ROCKWALL TOWNE CENTRE  
FIRST FILING  
A 5.1974 ACRE SUBDIVISION OUT  
OF THE  
E.P. GAINES CHISUM SURVEY, A-64  
and the  
JAMES SMITH SURVEY, A-200  
CITY OF ROCKWALL ... ROCKWALL COUNTY ... TEXAS

Re: Second Review  
Rockwall Towne Center  
ROK 84877

RE: First Review  
Rockwall Towne Centre  
ROK 84877

Rockwall Towne Centre Final Plat

FIGURE 1

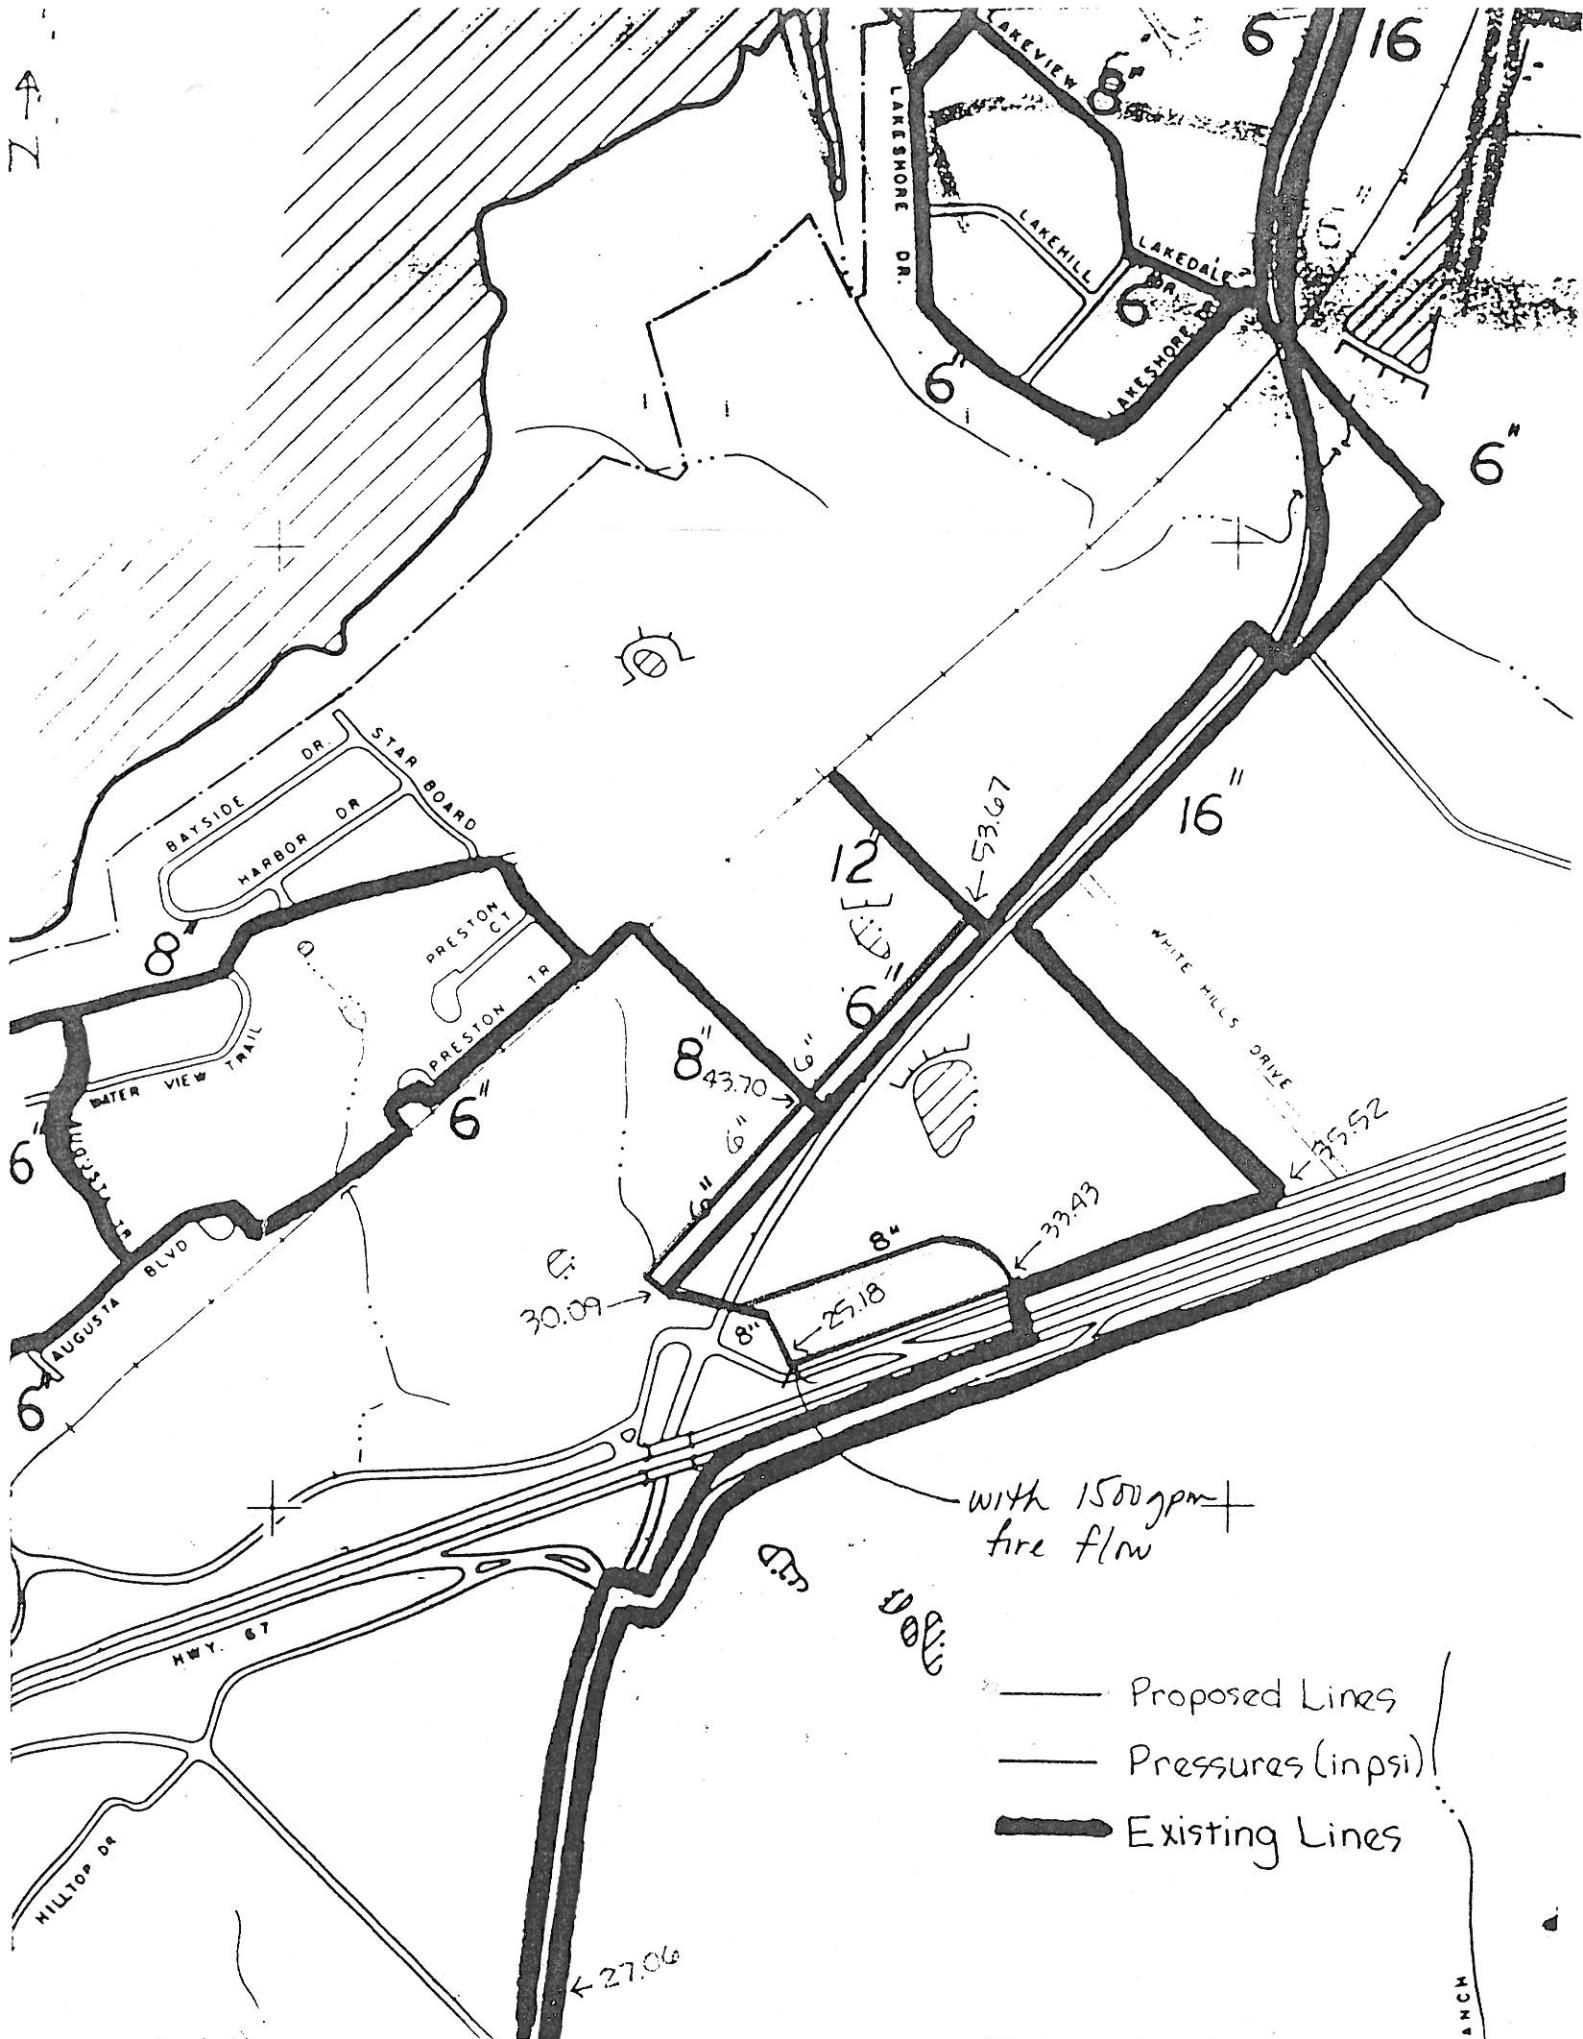
1. As per the water distribution system analyses made in the first review, the proposed system will not meet the State's fire protection standards.
2. In order to be able to meet the fire demand of 1,500 gpm with a residual pressure of 20 psi, a looped 8-inch pipeline within the development which is tied to the 16-inch pipeline to the east and to parallel 6-inch pipelines along F.M. 740 will be required as recommended in the first review.

With this configuration as illustrated in Figure 1, the resulting pressures will be 25 psi assuming the 24-inch pipeline extension from the Heath Street Pump Station is in place.
